## **Consideration of Comments**

Definition of the Bulk Electric System (Project 2010-17)

The Bulk Electric System Drafting Team thanks all commenters who submitted comments on the 2<sup>nd</sup> draft of the Definition of the Bulk Electric System (Project 2010-17). These standards were posted for a 45-day public comment period from August 26, 2011 through October 10, 2011. Stakeholders were asked to provide feedback on the standards and associated documents through a special electronic comment form. There were 113 sets of comments, including comments from approximately 255 different people from approximately 156 companies representing all 10 Industry Segments as shown in the table on the following pages.

#### Pacificorp additional comments:

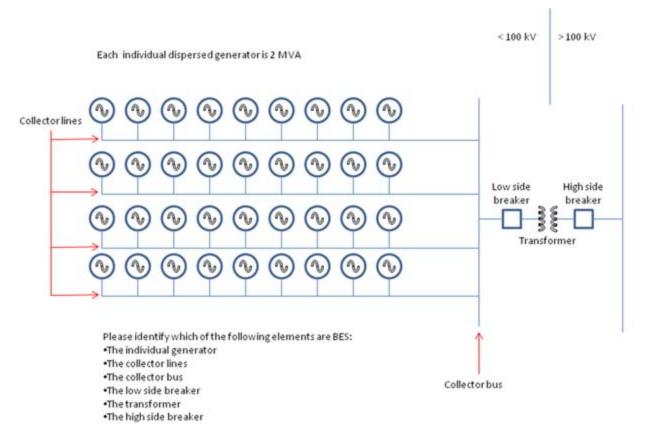
5. The SDT has revised the specific inclusions to the core definition in response to industry comments. Do you agree with Inclusion I4 (dispersed power)? If you do not support this change or you agree in general but feel that alternative language would be more appropriate, please provide specific suggestions in your comments.

No: X
